In revit a 3D beam element eg an I beam is represented on plan as a chain dotted line. ——— · ——— · ———
The family of beams difines where this line is positioned relative to the actual 3D model. For a symetrical member this is positioned in the centre of the element but it appears that for non symetrical elements such as PFC's the chain dot line is located at the ~~centroid~~ neutral axis.

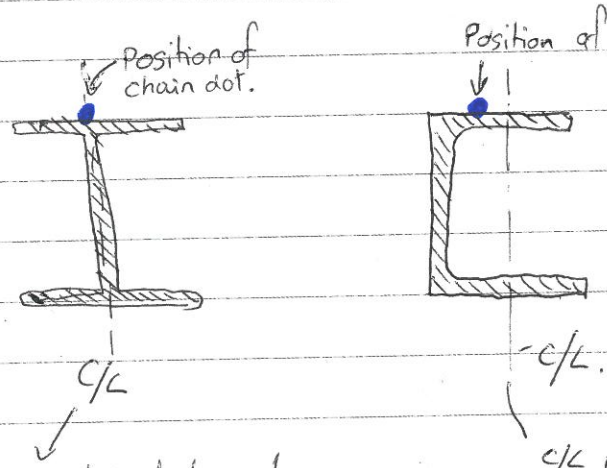
Options (1) we dim to the neutral axis of all steels (NOT a good idea)

(2) We try to find a way to change where chain dot is displayed (may take time/have unknown effects).

(3) we use details to set out these elements.

which should we do?
